NEW FIRE STATION: ENGINE CO. 268 / LADDER CO. 137

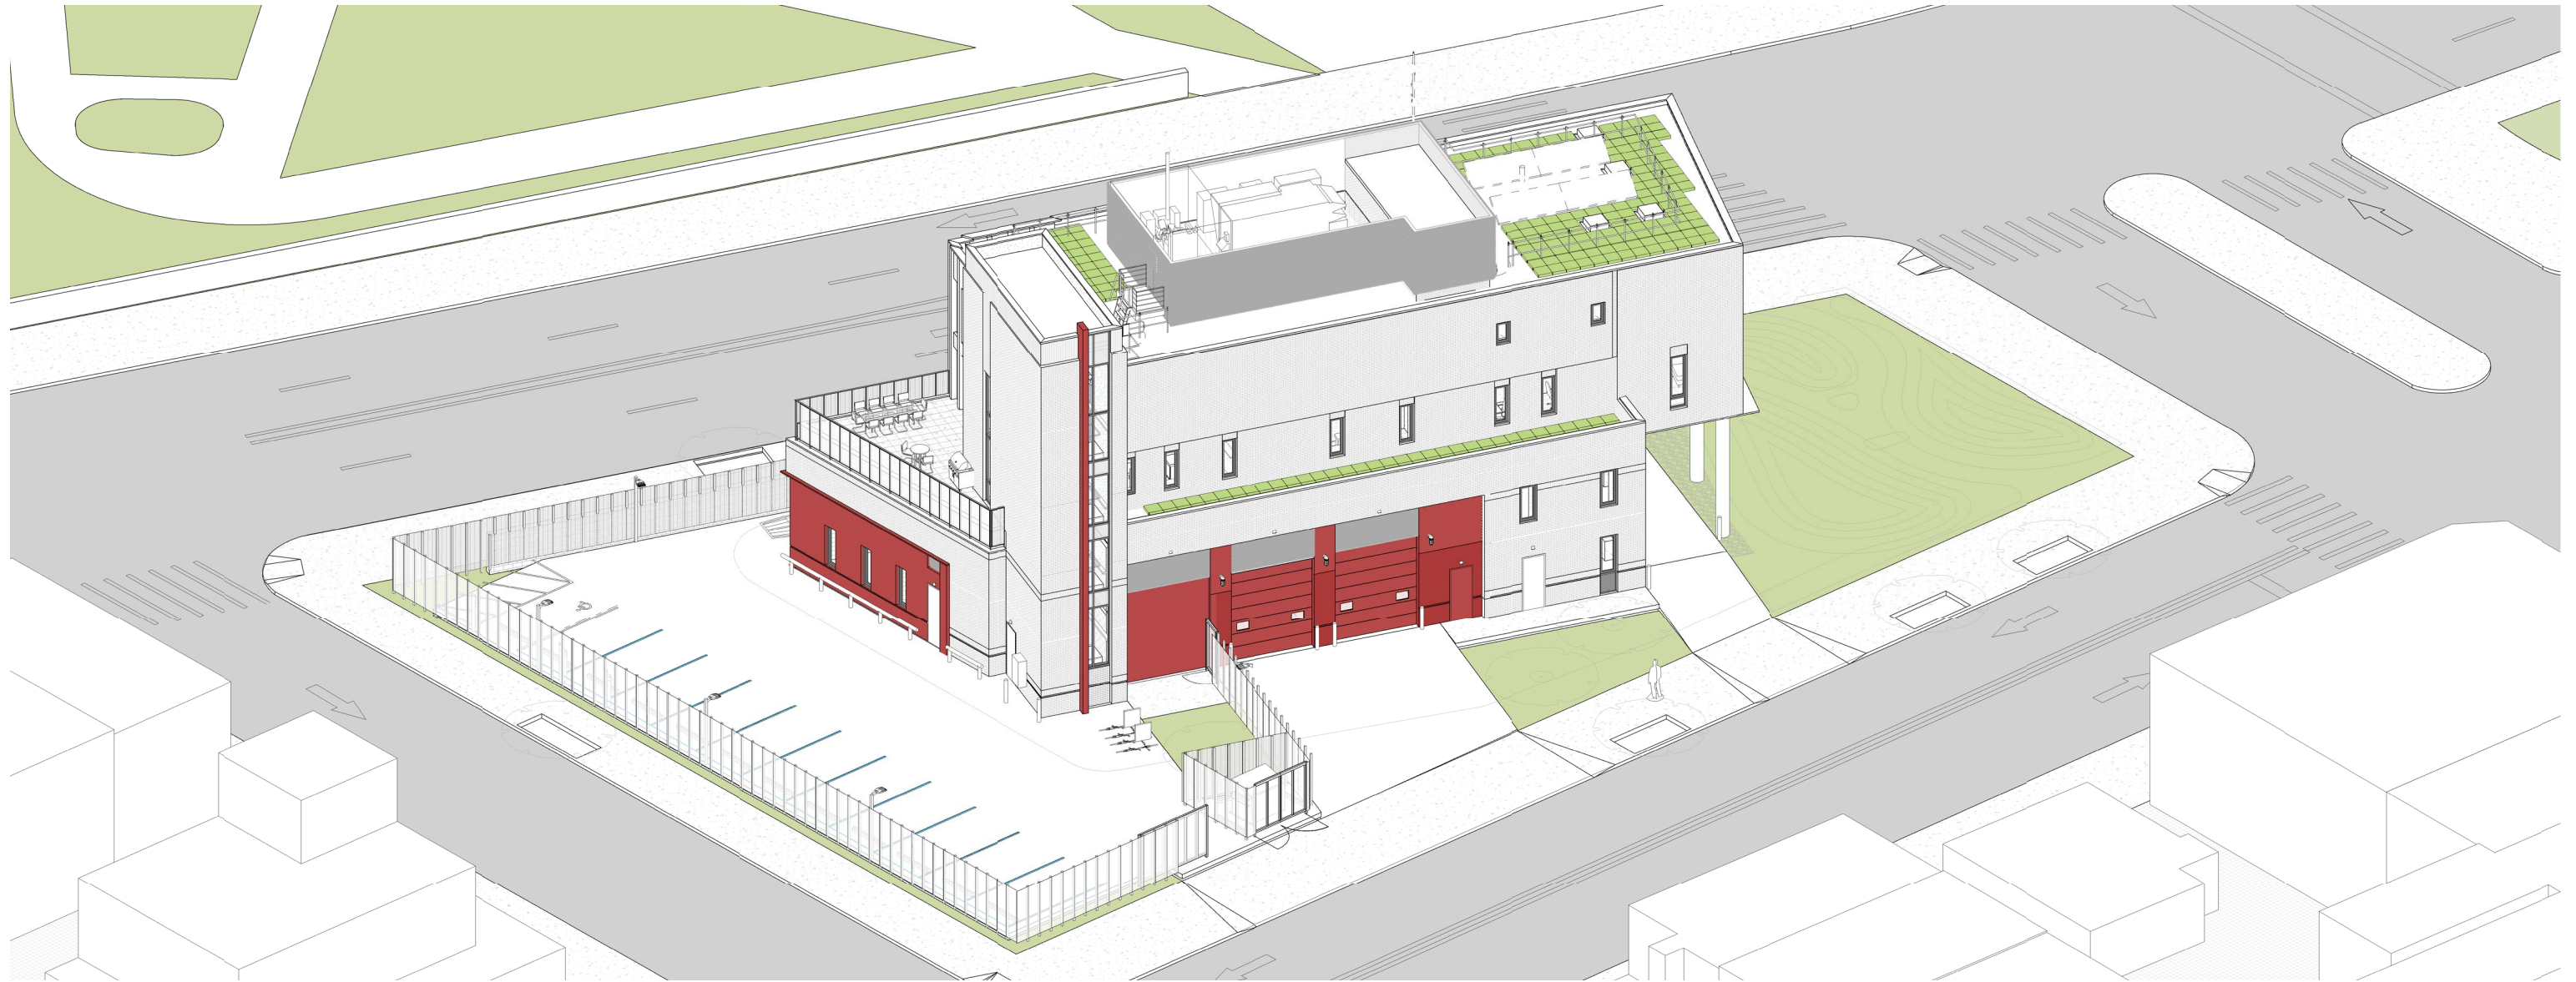
R41 - SLOTTED WINDOW ADDED AT SLIDE POLE

R42 - ROOF DECK AREA ADDED TO STRESS REDUCTION ROOM. BRICK "PIER" SPACING REVISED
